CCP23

Advice to the AER on the AusNet Services  
Transmission Revised Regulatory Proposal and AER Draft  
Determination for the  
Regulatory Determination 2022-27

**AER Consumer Challenge Panel – Sub-Panel CCP23**

5<sup>th</sup> October 2021

**Figure 5.2: Technologies currently deployed on the SW Comms Loop**

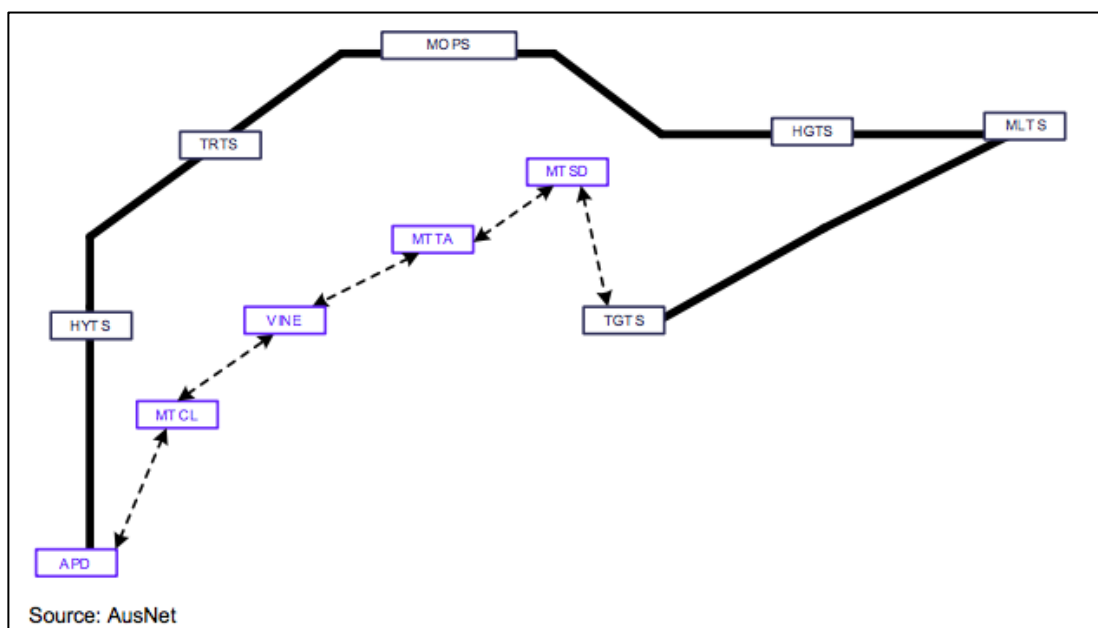
The solid line in Figure 7.2 above represents the sections of the Loop where optical fibre ground wire (OPGW) is already installed. The dashed line represents the section currently relying on microwave radio. These two lines represent the ‘physical layer’ of the communications path. The majority of AusNet Services’ communication network throughout the state now relies on OPGW technology.

While CCP23 had some initial concerns with this project, we acknowledge that AusNet Services has now provided a clearer explanation of the project and its economic evaluation. CCP23 concludes that it is in the long-term interests of consumers generally for the project to proceed as a replacement project

CCP23's question to the AER is to clarify whether the positive evaluation of the OPWG option (relative to the more microwave towers option) is dependent on, or at least substantially affected by, the prospect of expanded communication requirements under the REZ program.
